SCOTTSVILLE PHASE 4A WATER MAIN REPLACEMENT
ACSA Project No. 2019-03

Addendum 1
July 30, 2026

ALBEMARLE COUNTY SERVICE AUTHORITY
ALBEMARLE COUNTY, VIRGINIA

SCOTTSDALE PHASE 4A WATER MAIN REPLACEMENT ADDENDUM 1

1. Sheet 24 of 33 – Maintenance of Traffic Notes/Plans

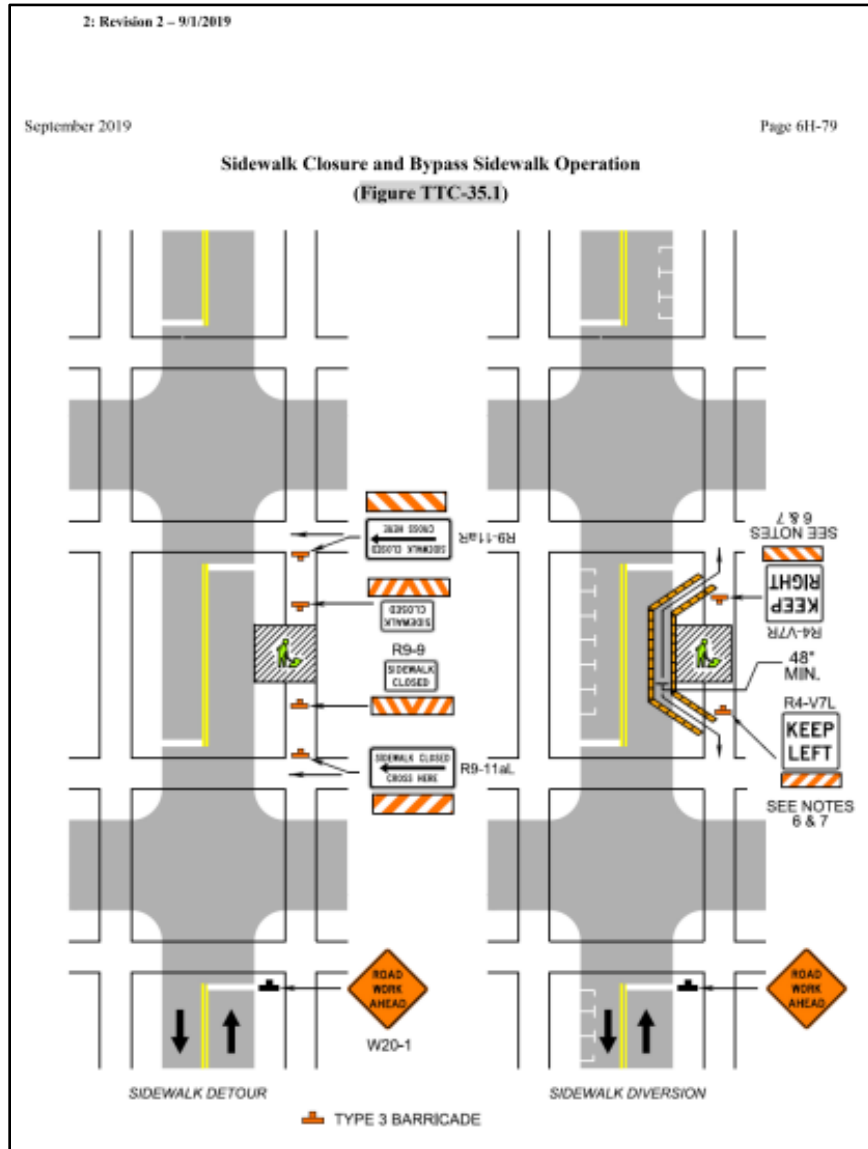
INSERT the following notes and figure for Typical Traffic Control – Sidewalk Closure and Bypass Sidewalk Operation (TTC-35.1) to replace the missing reference note on the sheet:

Page 6H-78	September 2019
Typical Traffic Control <i>Sidewalk Closure and Bypass Sidewalk Operation</i> (Figure TTC-35.1) <u>NOTES</u>	
Standard: 1. When crosswalks or other pedestrian facilities are closed or relocated, temporary facilities shall be detectable and shall include accessibility features consistent with the features present in the existing pedestrian facility.	
Guidance: 2. Where high speeds are anticipated, a temporary traffic barrier and, if necessary, a crash cushion should be used to separate the temporary sidewalks from vehicular traffic. 3. Audible information devices should be considered where midblock closings and changed crosswalk areas cause inadequate communication to be provided to pedestrians who have visual disabilities. 4. Temporary markings should be considered for operations exceeding three days in duration.	
Option: 5. Only the TTC devices related to pedestrians are shown. Other devices, such as lane closure signing or ROAD NARROWS (W5-1) signs, may be used to control vehicular traffic. 6. For nighttime closures, Type A Flashing warning lights may be used on barricades that support signs and close sidewalks. 7. Signs, such as KEEP RIGHT (R4-V7R) and KEEP LEFT (R4-V7L), may be placed along a temporary sidewalk to guide or direct pedestrians.

Standard: 8. All sidewalk closures shall be closed with Type 3 Barricades. The SIDEWALK CLOSED (R9-9) sign and the SIDEWALK CROSS HERE (R9-11) sign shall be installed above the Type 3 barricade. The KEEP RIGHT sign can cover the top rail of the Type 3 Barricade.²
